‘Allfarthing’ 2 Brisbane Grove Road Gateway Determination Review

PP-2024-295

Advice Report

30 April 2025

Image 9: Braidwood Road crossing of Mulwaree River – Long Section

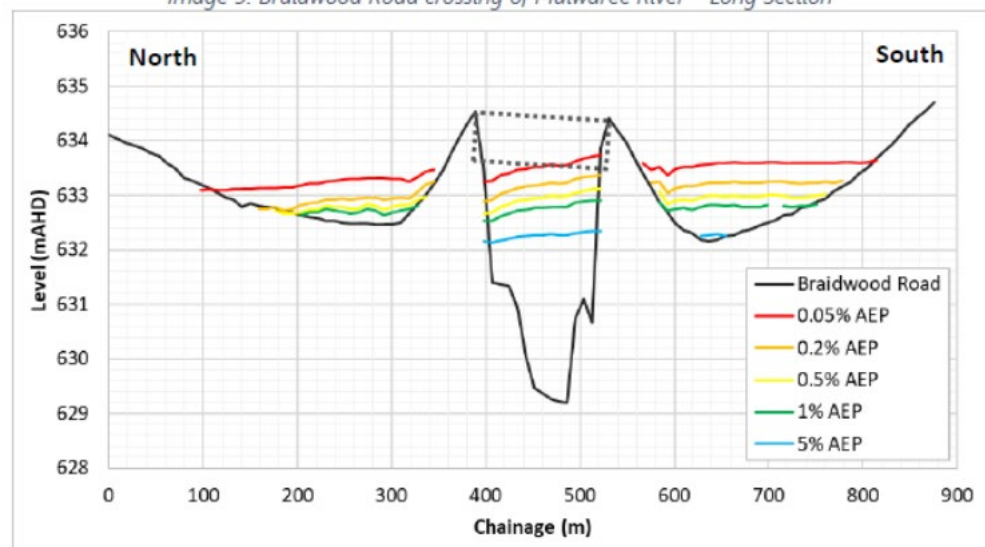
- With specific reference to the last dot point in the adjoining column (issue raised by SES): "concern the entirety of the site becomes frequently isolated from vehicular access/egress in at least the 10% AEP event .." – this has been raised for the first time amongst all other comments and responses. It is unclear where the data used for the 10% AEP reference has come from, and it is inconsistent with the FIRA submitted in support of the planning proposal, as well as the information derived for the Goulburn FRMSP.
- With reference to the above long section of the Braidwood Road crossing, flood water only begins to flow across the roadway in the events equal to or greater than the 5% AEP.
- In relation to a merit-based assessment of the proposal we submit the

- At what water depth and velocity does isolation not become inundation, and similarly, when does inundation cease – at zero depths of water or some other pre-determined level? The transition between 'flood hazard' categories should be the driving considerations for inundation and therefore the period of 'total inundation' is not a correct measure.

Figure 30: Flood depth Map along Braidwood Road Evacuation route

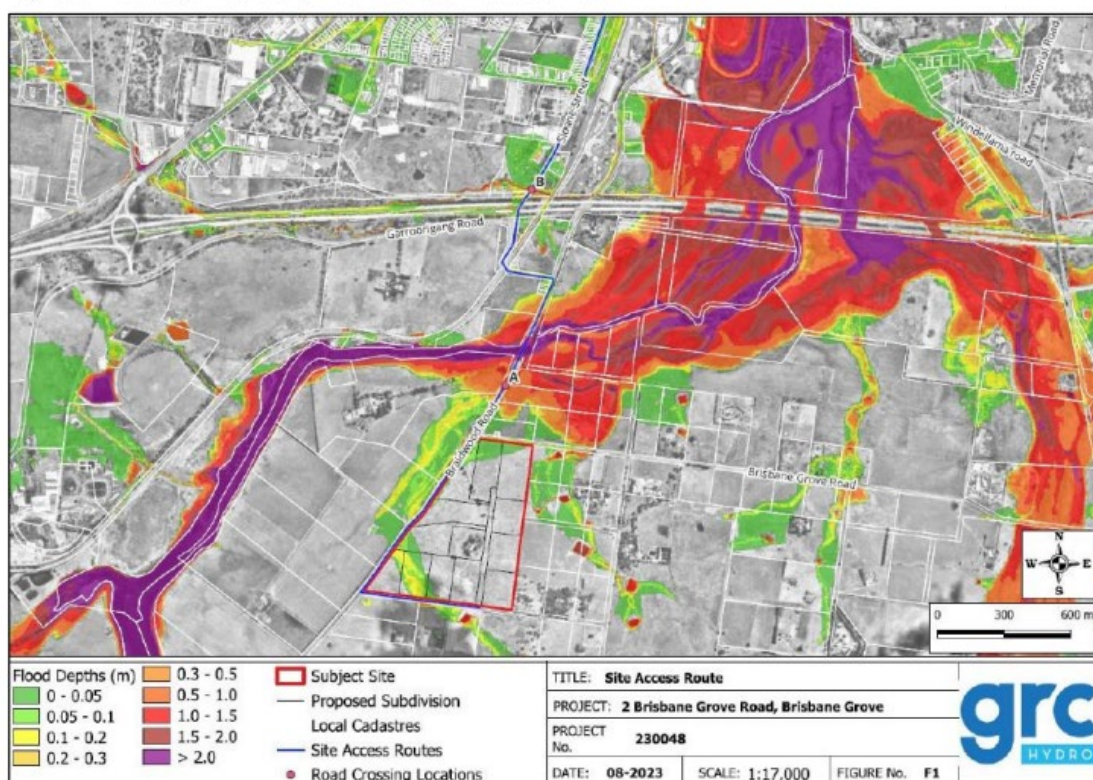
The planning proposal and FIRA states that the only realistic evacuation route from the site to the Goulburn Urban area is via Braidwood Road and over the Mulwaree River as shown in the figure below extracted from p.60 of the Planning Proposal.

The FIRA identified and assessed the frequency, severity and duration of flood inundation on Braidwood Road as presented in the table below (**Table 1**).

The table demonstrates that access from the site to the Goulburn urban area first becomes inundated during a 5% AEP flood event with minimum depth of 0.03m. Braidwood Road becomes inundated to a hazardous extent at the 1% AEP event with a depth reaching 0.57m with a total duration of 22.5 hours and inundated to a depth of 8.6m for a duration of up to 38 hours during the PMF flood.

Figure 3 – 1% AEP Event – Flood Depth/Levels/Flood Hazard (Source: GRC Hydro FIRA)

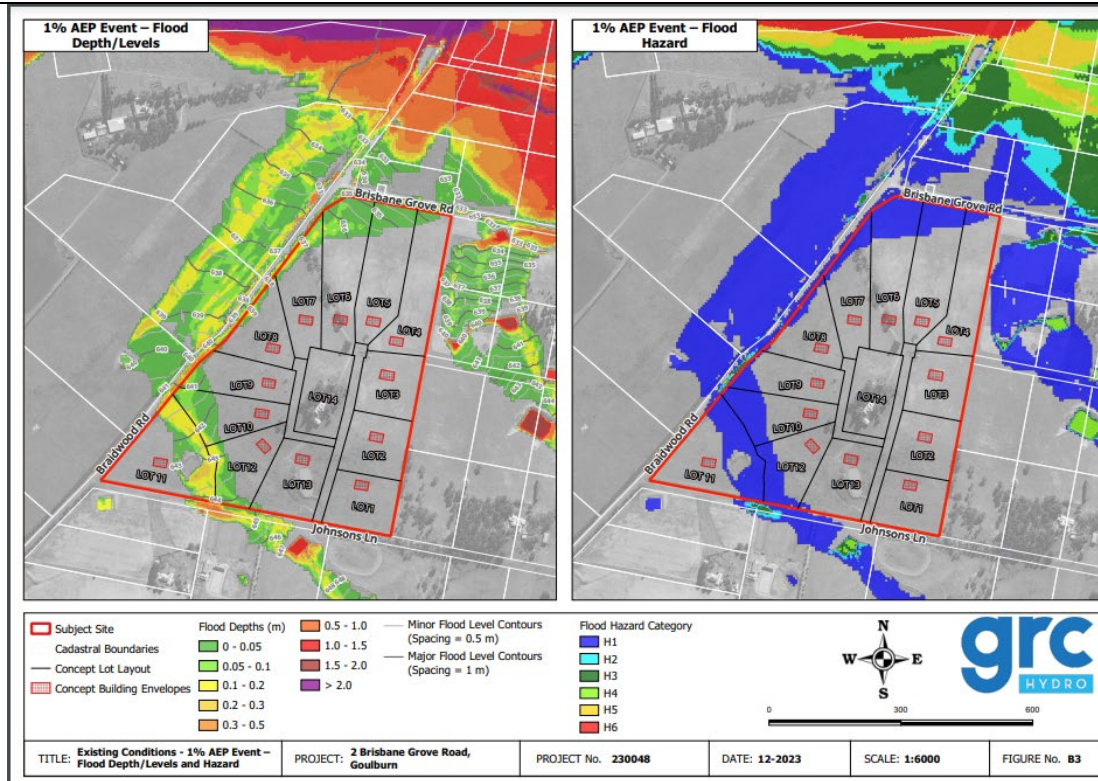
The planning proposal identifies that whilst all dwellings will be flood free up to and including a PMF event, residents are likely to be isolated in their homes (and immediate surrounds) for an extended period of time, because the limited available flood warning times for floods at the 1% AEP or rarer events in the local catchment would largely rule out self-evacuation as a suitable emergency management response during these flood events. The FIRA identifies that Braidwood Road is expected to be hazardous for crossing during this time as shown in Figure 3 below.

In assessing whether the period of isolation for future dwellings on the site during flood events, the Department referred to the draft “Shelter-in-Place Guidelines” as an indicative guide. The draft Guideline, which was placed on public exhibition from January 2023 until February 2023, recommended that occupants should not shelter-in-place for more than six hours.
